Executive Director's Recommendation

Commission Meeting: May 2, 2019

PROJECT Perimeter Fence Replacement and Gate Improvements United States National Arboretum 3501 New York Avenue, NE Washington, DC	NCPC FILE NUMBER 8064
SUBMITTED BY United States Department of Agriculture National Arboretum	NCPC MAP FILE NUMBER 43.20(38.40)44910
REVIEW AUTHORITY Federal Projects in the District per 40 U.S.C. § 8722(b)(1) and (d)	APPLICANT'S REQUEST Approval of comments on concept design
	PROPOSED ACTION Approve comments as requested
	ACTION ITEM TYPE Staff Presentation

Proposal: Gates

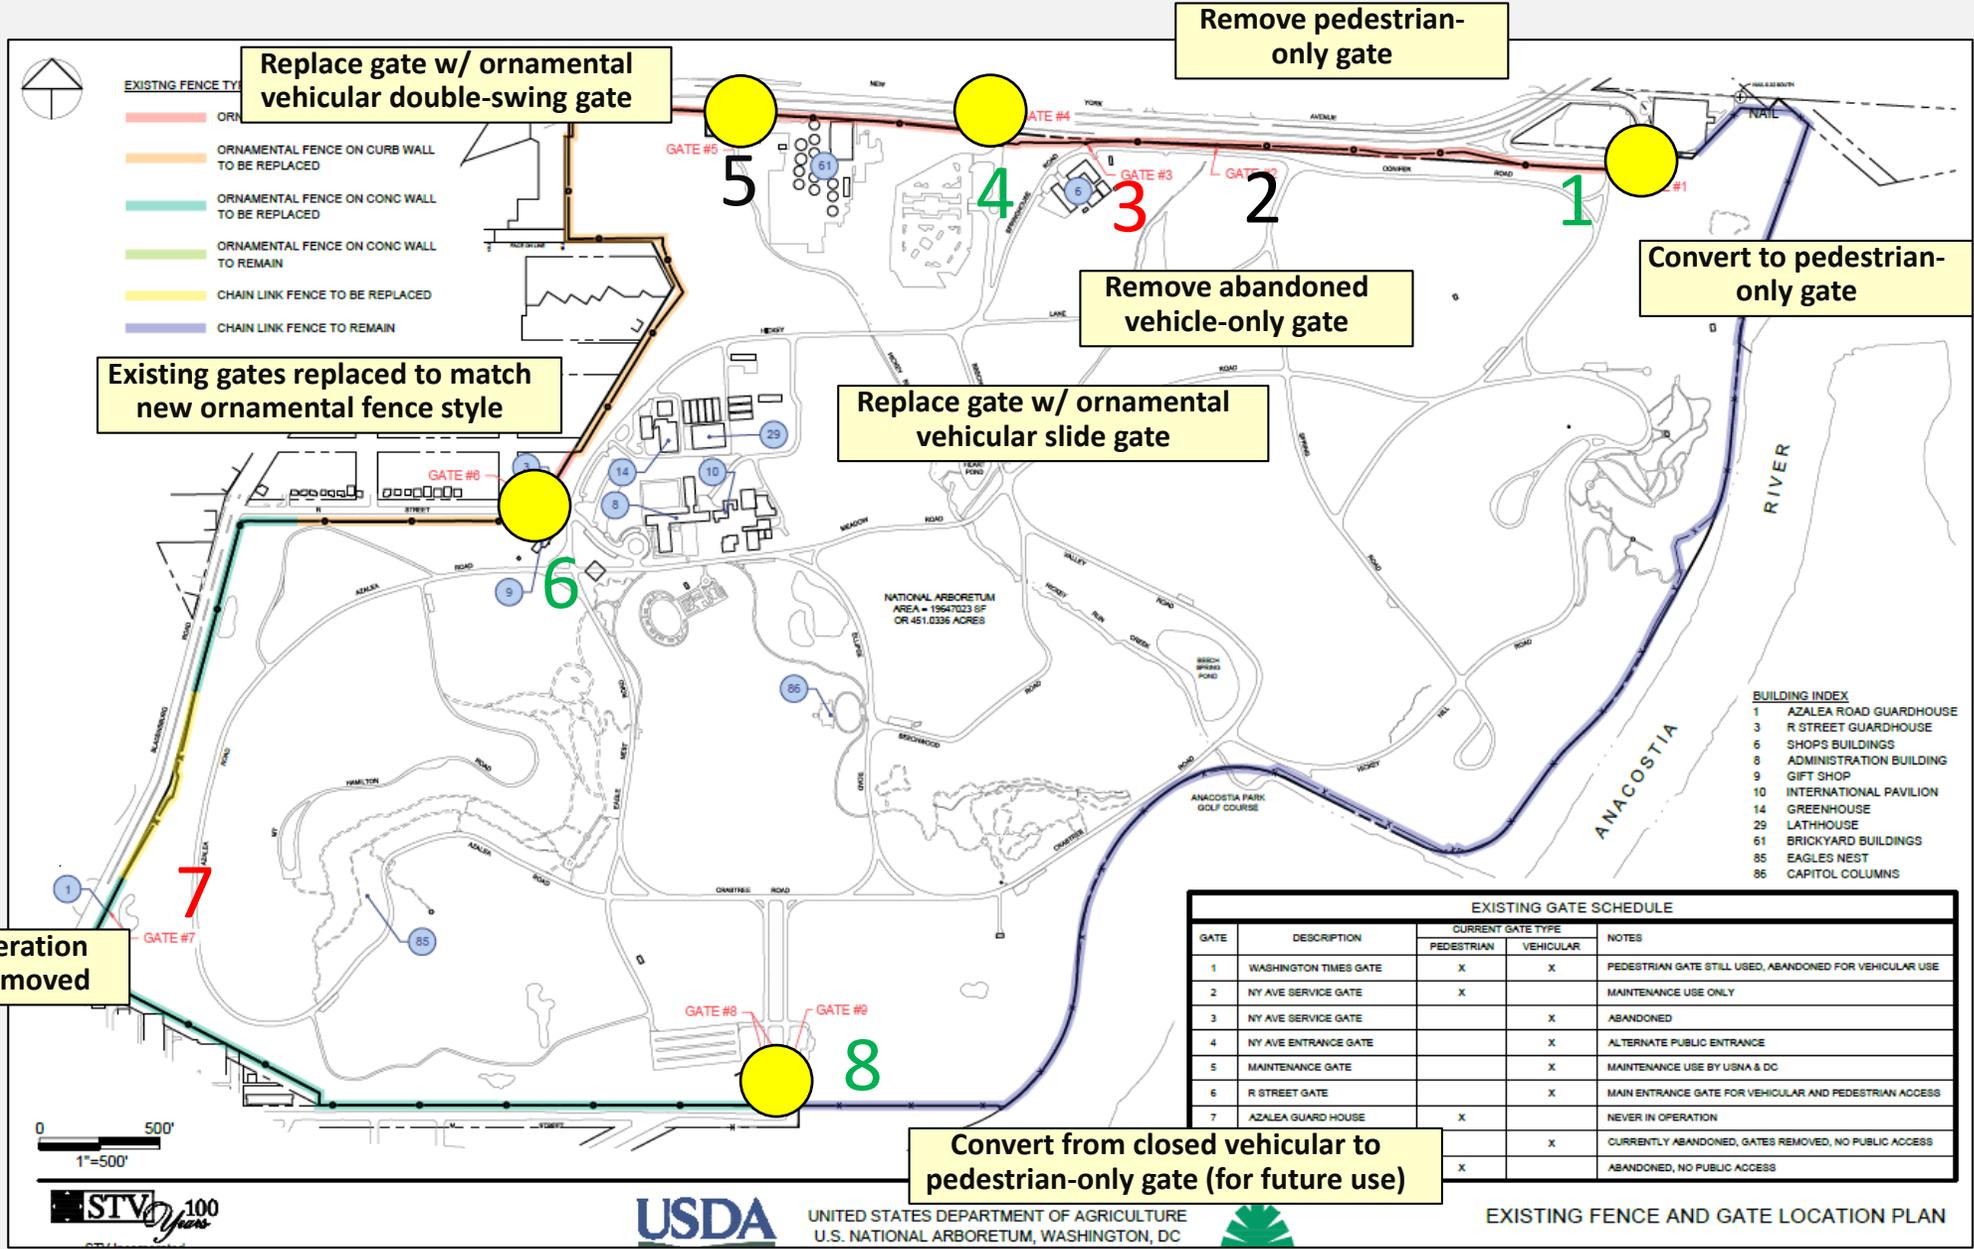
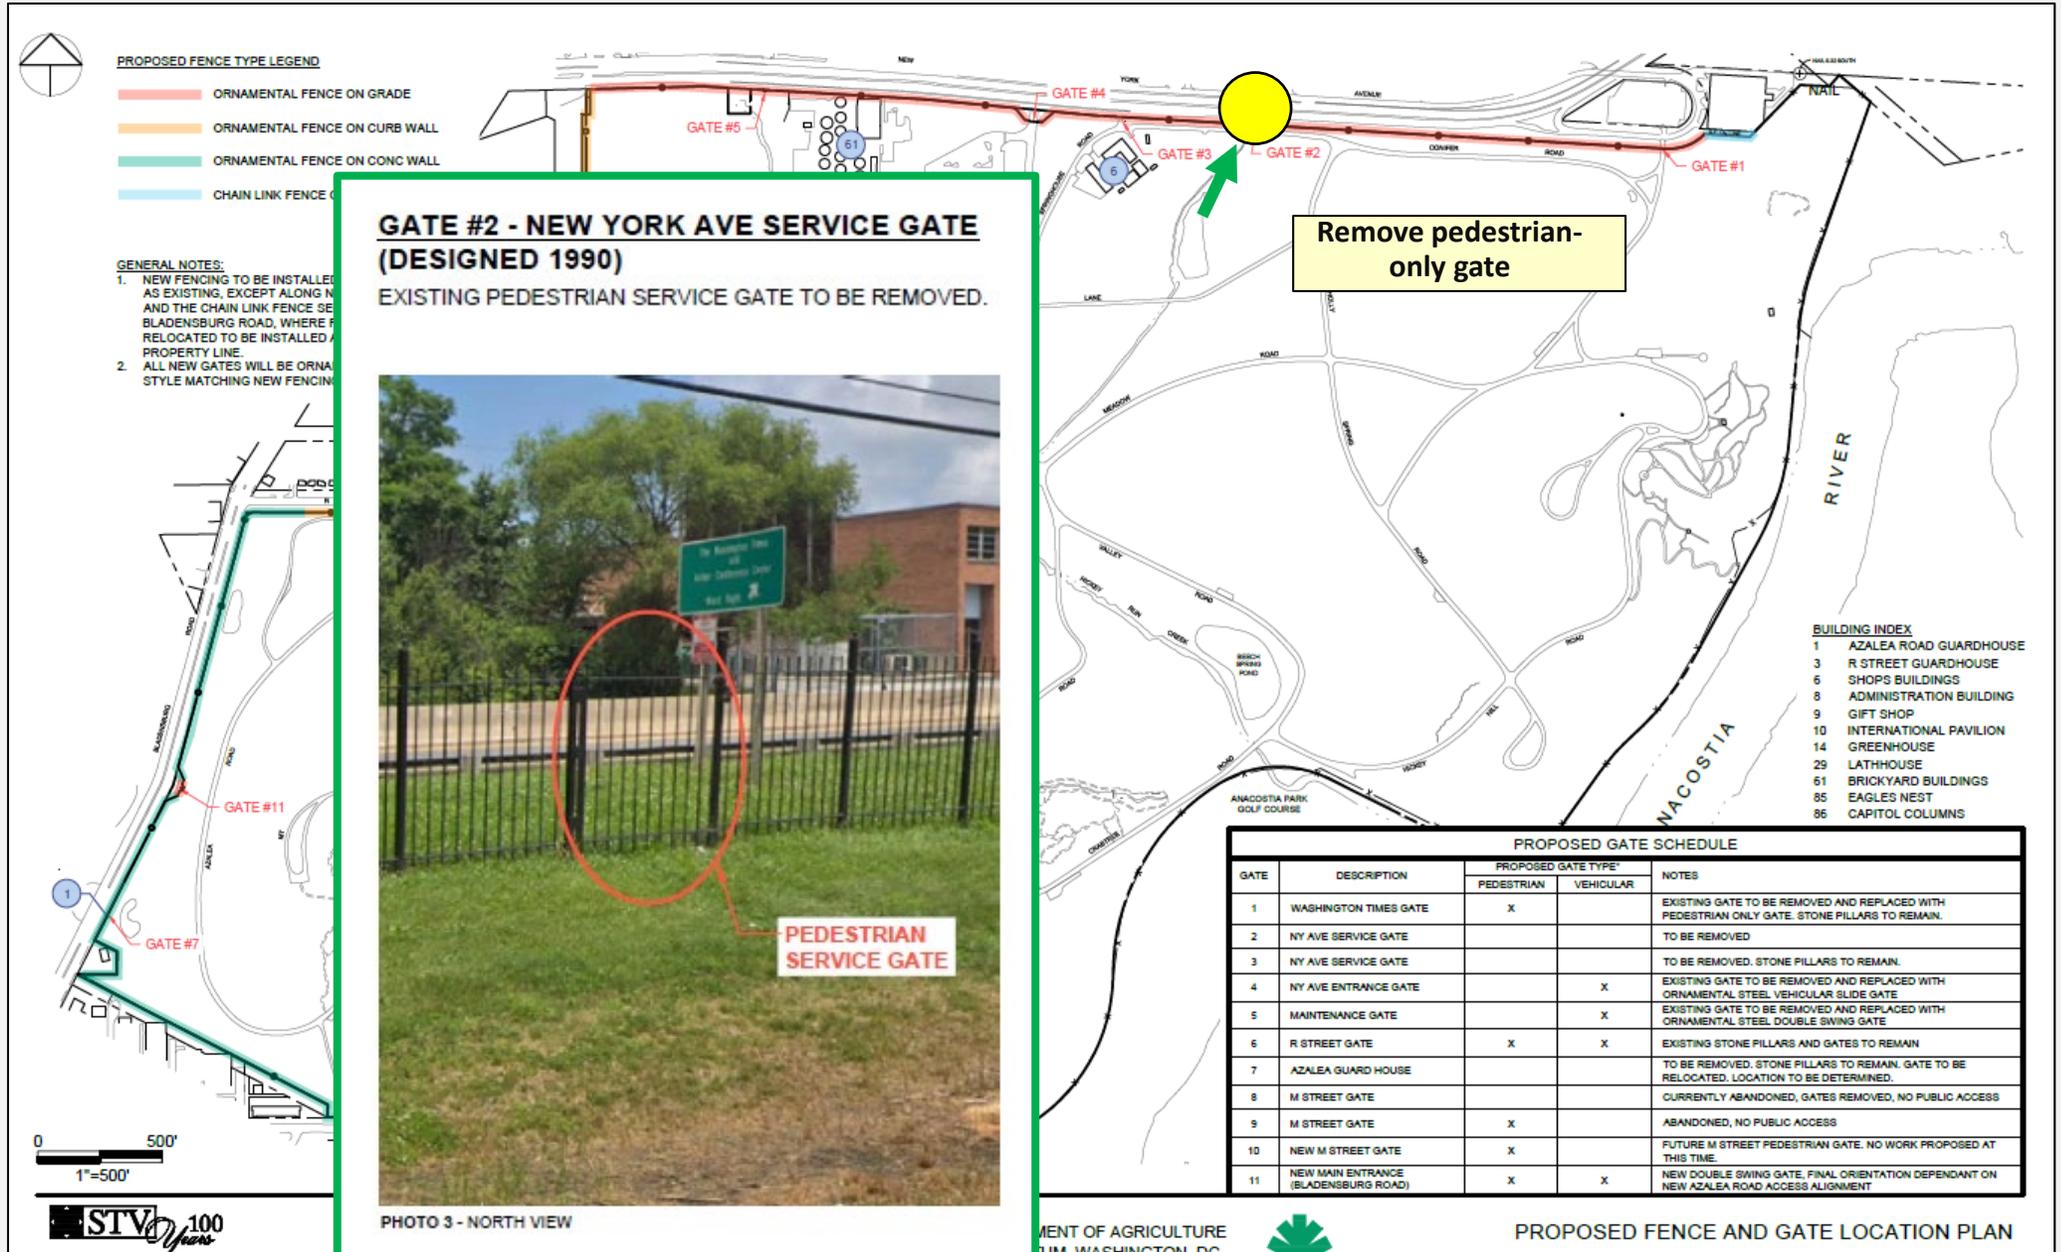
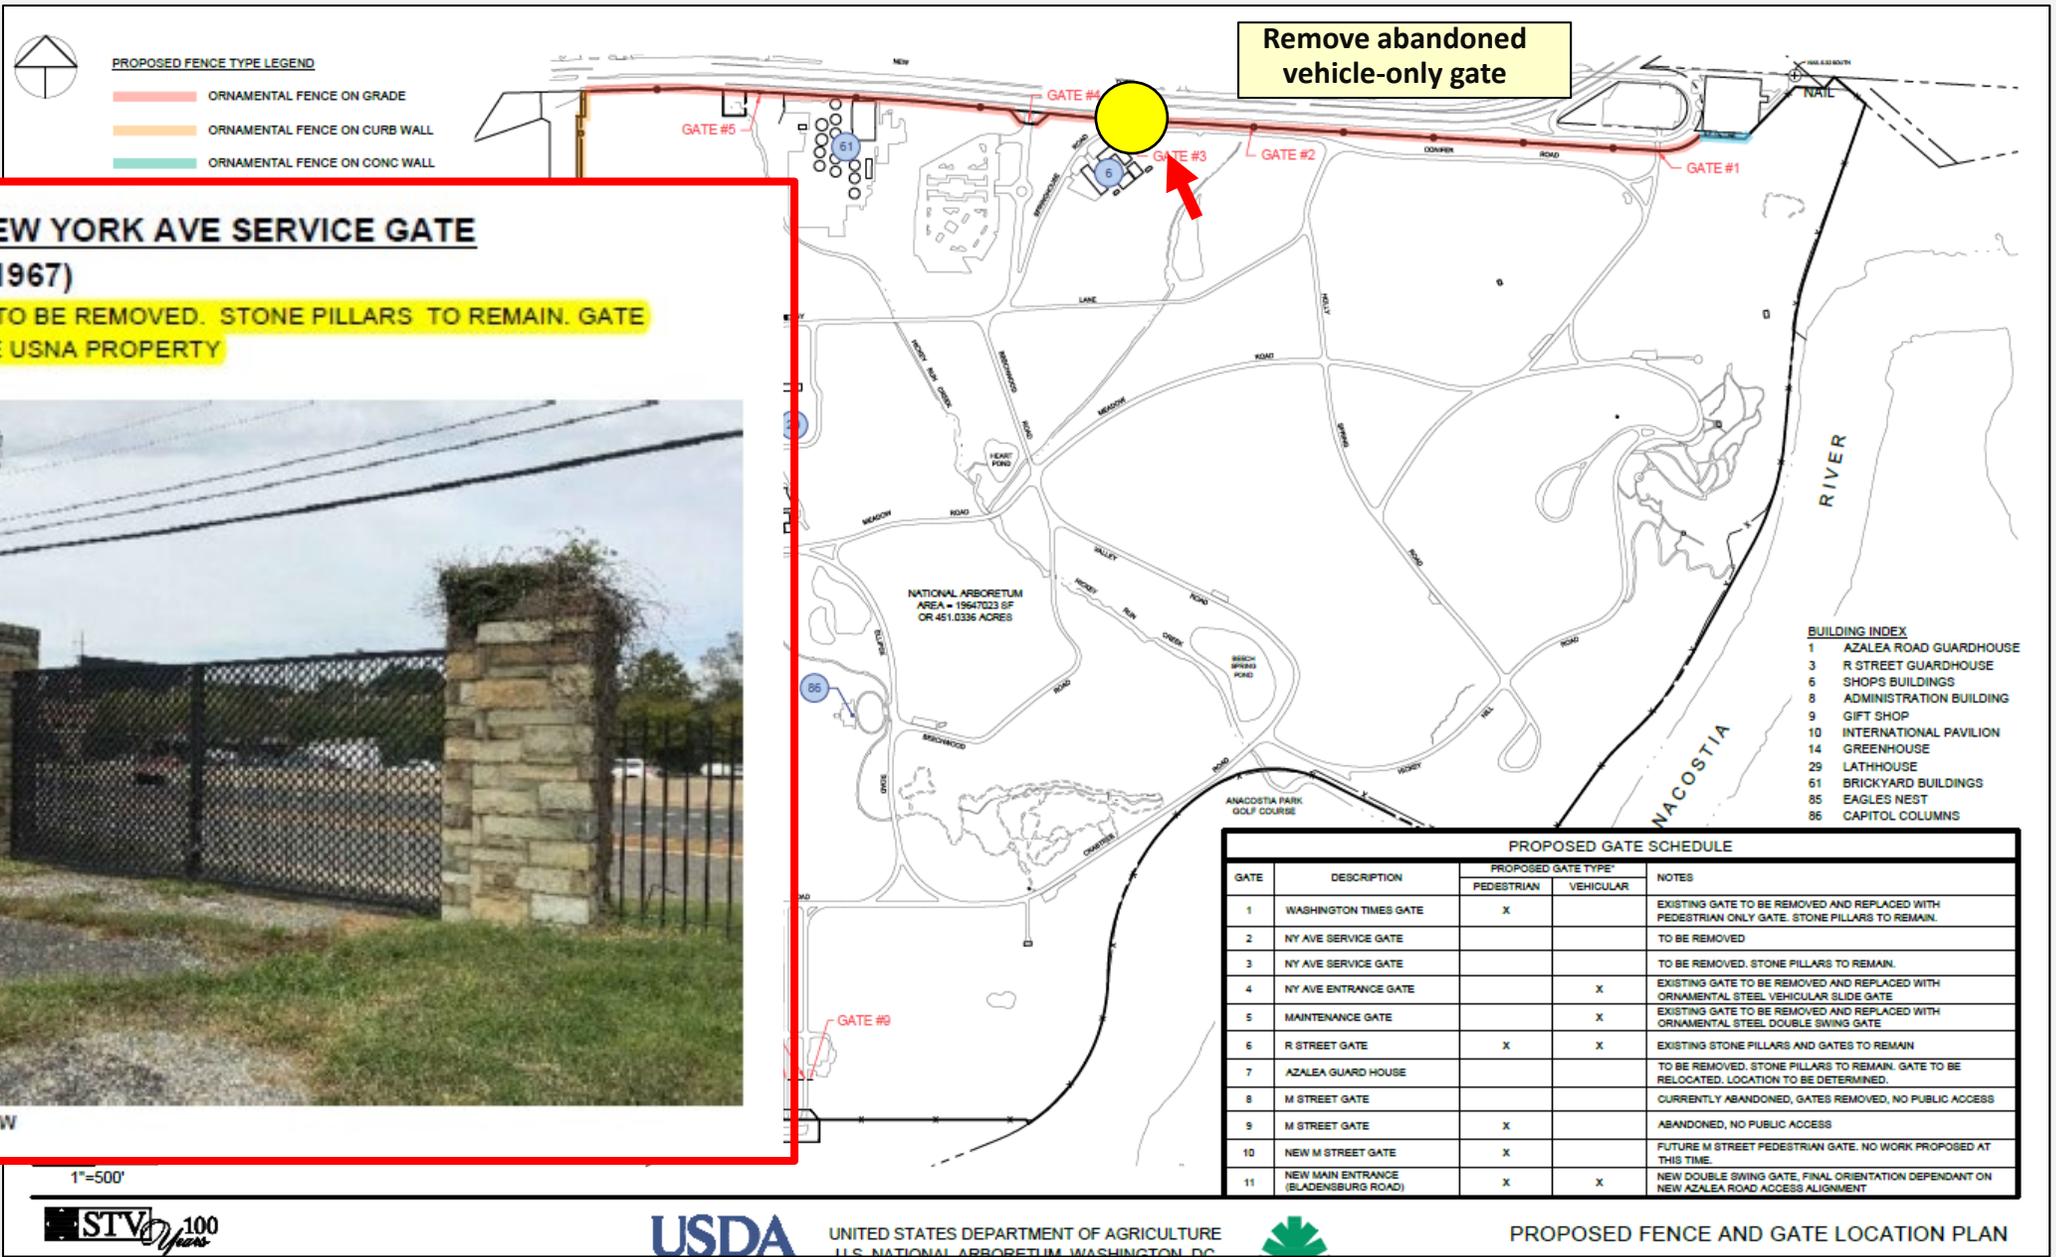
Requests a phasing plan as part of the next submission to understand the order in which the USNA gates will be opened, modified, or closed, and how this sequence will accommodate visitors and Arboretum operations, while minimizing any impacts to on- and off-site access and circulation.

Requests detailed plans, elevations, technical specifications, and renderings for each proposed perimeter gate modification.

With exception of the R Street gate, the concept plan identifies three types of modification actions for the other six existing gates including: 1) Complete removal (with no replacement) and re-establishment of the perimeter fence, 2) Conversion to a different use, and 3) Replacement of the moveable gate arms to match the new picket fence style. In total, the Arboretum will completely remove two pedestrian gates (Gates 2 and 7) and one vehicular gate (Gate 3.) One gate will be converted from a combined vehicular/pedestrian gate into a pedestrian-only gate (Gate 1.) Lastly, three gates will have their swing arms placed with new movable arms that match the style of new decorative fencing; Two of these will remain "swing" gates (with inward-moving arms), and one gate will be converted into a "slide" gate. The concept plan includes photographs as examples of potential new swing and slide gates. In light of the proposed gate modifications, which will impact on- and off-site circulation, staff recommends that the Commission **request a phasing plan as part of the next submission to understand the order in which the USNA gates will be opened, modified, or closed, and how this sequence will accommodate visitors and Arboretum operations, while minimizing any impacts to on- and off-site access and circulation.**
